Re: Mine Inspection April 30, 2009
Property: Pumptown Quarry

Mining & Mineral Division
Report of Inspector of Mines
(Issued pursuant to Section 15 of the *Mines Act*)

NAME OF MINE	Pumptown Quarry	LOCALITY	49.117, -122.113 ABBOTSFORD
OWNER/OPERATOR	Pumptown Quarry Inc.	ADDRESS	31992 South Fraser Way Abbotsford BC V2T 1V6
MANAGER	Scott Campbell	AREAS INSPECTED

Photo 2 View of the upper portion of the access ramp at the current heading. The road cut changes direction at around Sta. 0+280 (photo left), resulting in some undercutting of the major structure and increasing the potential for blasting backbreak.

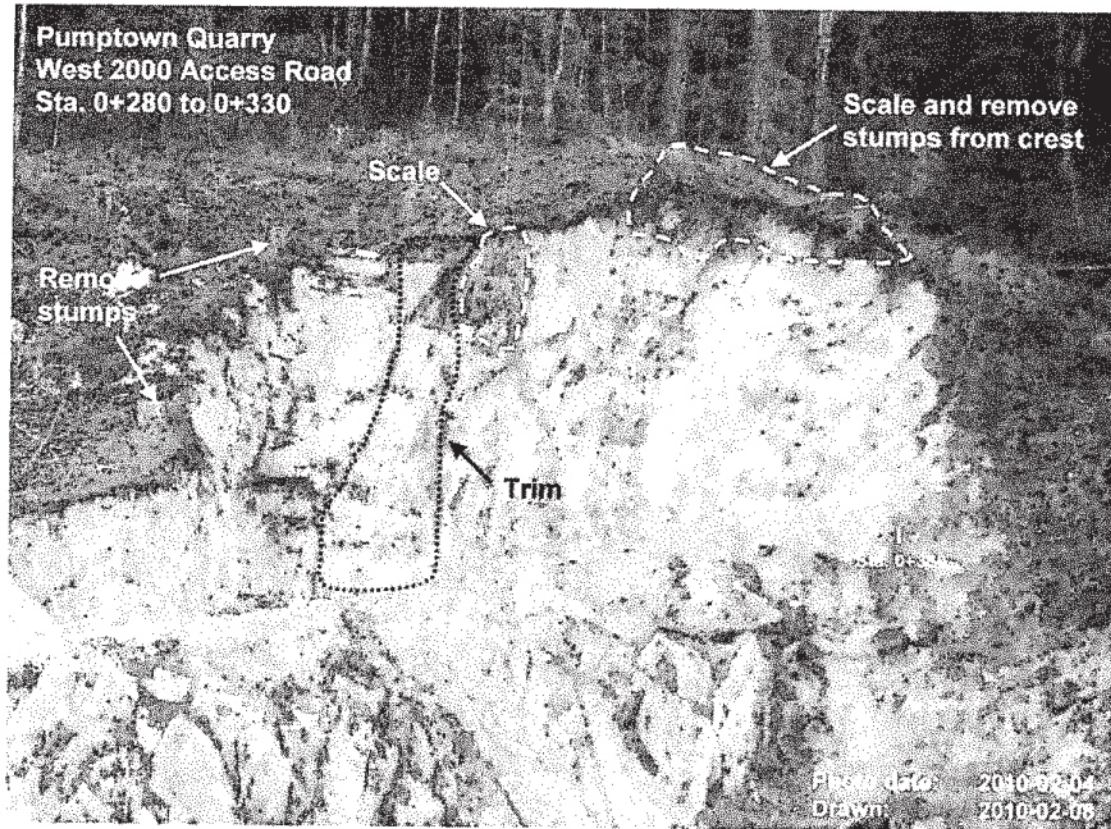
During my inspection, changes in the blasting and detonation procedures were also discussed. In blasting the bulk of the West 2000 ramp the blaster has been detonating the inside holes of the slash rounds first. This has the effect of confining the charge and reducing throw of flyrock from the blast face. Since dominant jointing was oriented parallel to the cut, any overbreak would usually come out with the blast or could be scaled with the hoe to a stable face. Due to the change in heading direction past Sta. 0+280 and the fact that more adverse structure is being exposed in the face, it is recommended that the detonation sequence be changed so that holes on the inside of the slash round are fired last. This will give more relief to these holes and reduce the potential for backbreak.

Photos 2 and 3: Visibly poorer quality rock mass with some dilating joints

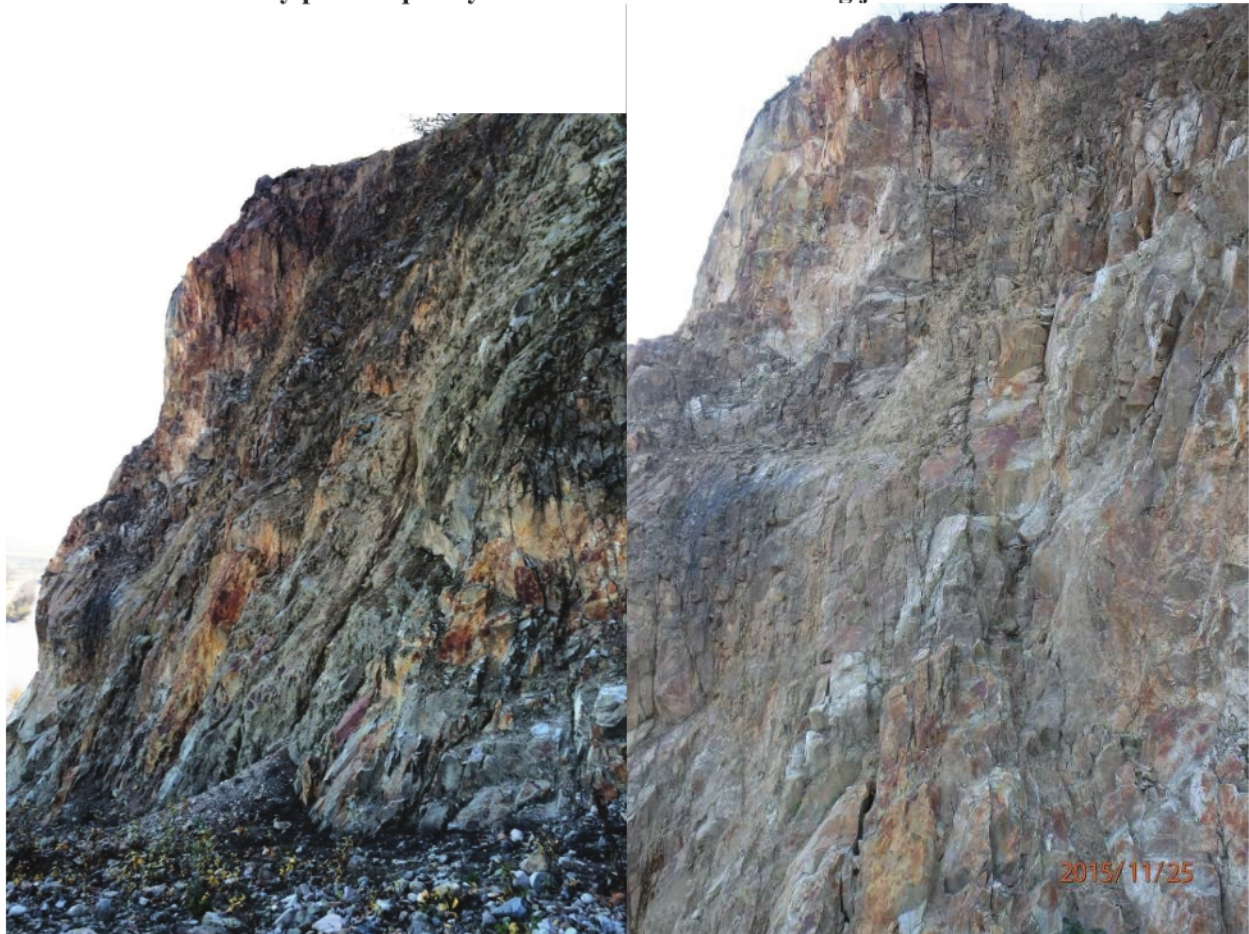
The quarry consists of granite and/or granodiorite which is generally fair to good quality. The south end of the excavation (near the access ramp switchback) was visibly poorer quality: slightly to moderately weathered with steeply dipping faults and sub-parallel joint sets. The rock appeared to be susceptible to wedge failure and planar toppling as evidenced by the dilated joints observed near the crest of some rock cuts (Photos 2 and 3).

Photo 2 View of the upper portion of the access ramp at the current heading. The road cut changes direction at around Sta. 0+280 (photo left), resulting in some undercutting of the major structure and increasing the potential for blasting backbreak.

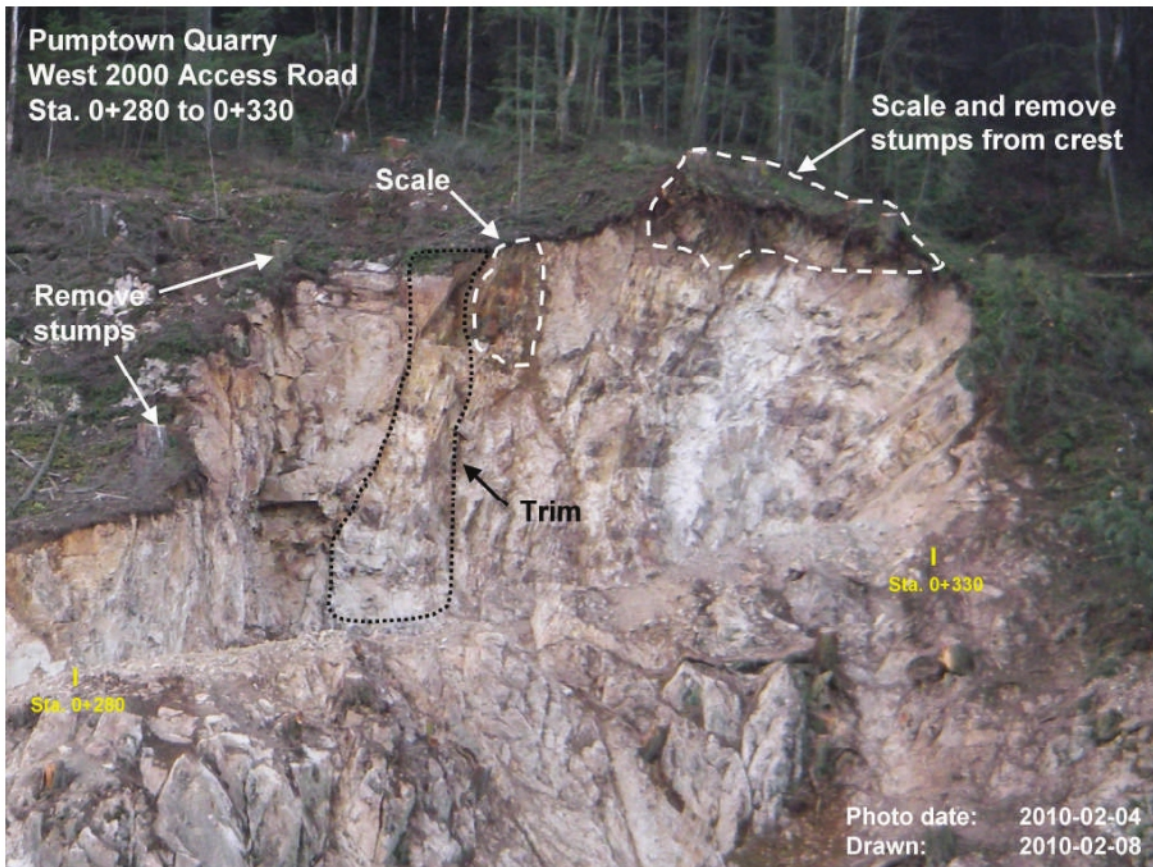
During my inspection, changes in the blasting and detonation procedures were also discussed. In blasting the bulk of the West 2000 ramp the blaster has been detonating the inside holes of the slash rounds first. This has the effect of confining the charge and reducing throw of flyrock from the blast face. Since dominant jointing was oriented parallel to the cut, any overbreak would usually come out with the blast or could be scaled with the hoe to a stable face. Due to the change in heading direction past Sta. 0+280 and the fact that more adverse structure is being exposed in the face, it is recommended that the detonation sequence be changed so that holes on the inside of the slash round are fired last. This will give more relief to these holes and reduce the potential for backbreak.
